Project	IEEE 802.16 Broadband Wireless Access Working Group < http://ieee802.org/16 >	
Title	Transmission Information of Customized MOB_NBR-ADV	
Date Submitted	2007-07-05	
Source(s)	Hyunjeong Kang, Jungje Son, Changyoon Oh Samsung Electronics Rakesh Taori Samsung Advanced Institute of Technology	Voice: 82-31-279-5084 E-mail: hyunjeong.kang@samsung.com
Re:	IEEE 802.16j-07/019; Call for technical comments regarding IEEE project 802.16j	
Abstract	This contribution proposes a method to provide the instruction to transmit MOB_NBR-ADV that is composed by RS.	
Purpose	Discussion and adoption in IEEE 802.16j	
Notice	<i>This document does not represent the agreed views of the IEEE 802.16 Working Group or any of its subgroups. It represents only the views of the participants listed in the "Source(s)" field above. It is offered as a basis for discussion. It is not binding on the contributor(s), who reserve(s) the right to add, amend or withdraw material contained herein.</i>

Transmission Information of Customized MOB_NBR-ADV

Figure A – BM BR header format

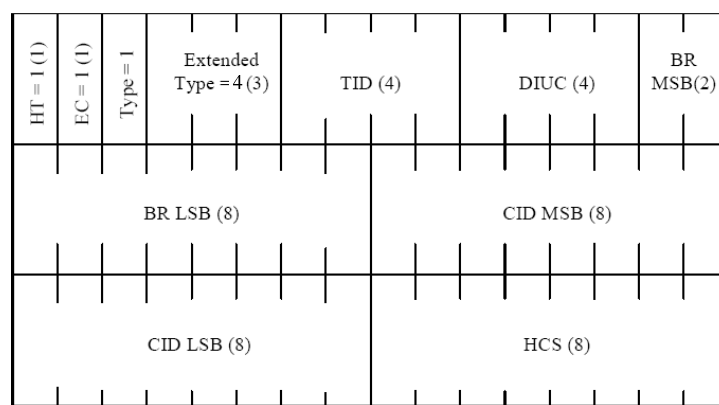
[Insert new subclause 6.3.2.1.2.2.2.5 at line 21 in page 14]

6.3.2.1.2.2.2.5 Broadcast Message bandwidth request header (BM BR)

BM BR header shall be sent by a RS to its MR-BS to specify the required bandwidth for the purpose of transmitting broadcast messages over access link that are composed by the RS. The format of this header is illustrated in Figure A and described in Table B.
